S E R V I C E N O T E

8665A Synthesized Signal Generator

Potential RPP Assembly Failures

DATE: 23 April 1993

Figure 1

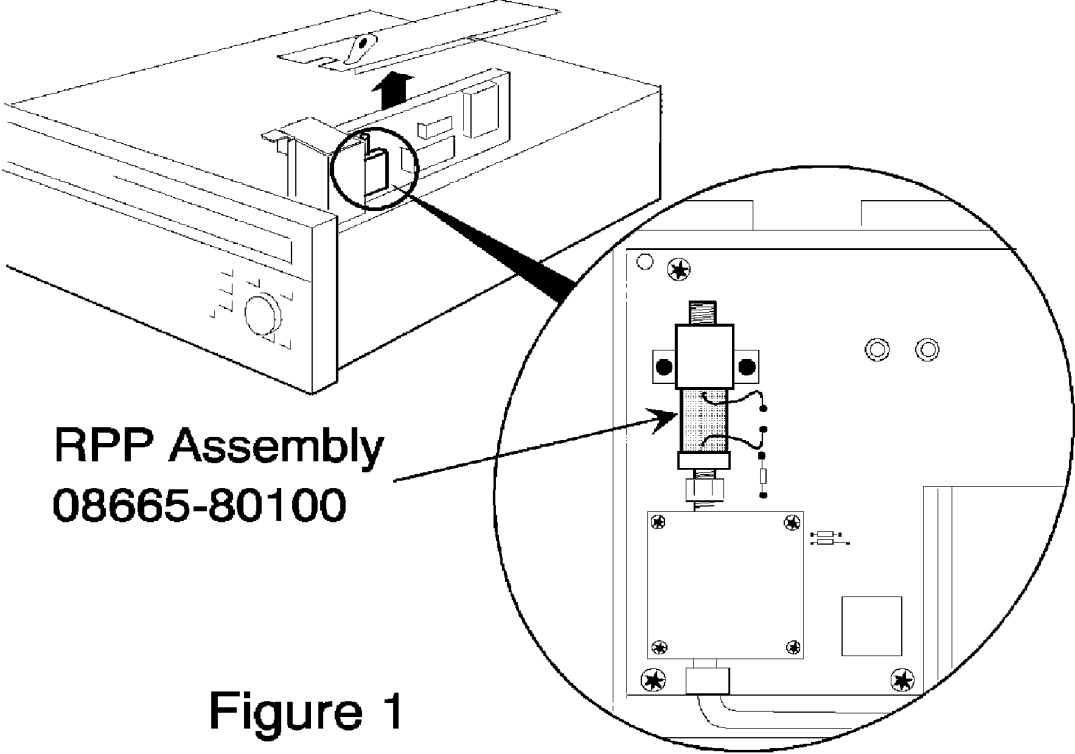
Instruments with specific serial numbers noted below may have defective RPP (Reverse Power Protection) assemblies. The RPP assembly protects the RF output circuitry from damage due to externally applied power. Failure symptoms include no RF output or a low output level (relative to front-panel settings).

The RPP fails when the elastomer expands beyond its nominal size and contacts the external connections of the reed relay. This causes a low impedance RF path to ground.

1. Remove the original RPP assembly and replace it with the part number listed above.
Refer to Figure 1 for assembly and component location.
2. Run the internal diagnostics after replacing the RPP assembly.
3. Perform RF Level Accuracy Performance Test to insure that the instrument meets specifications.
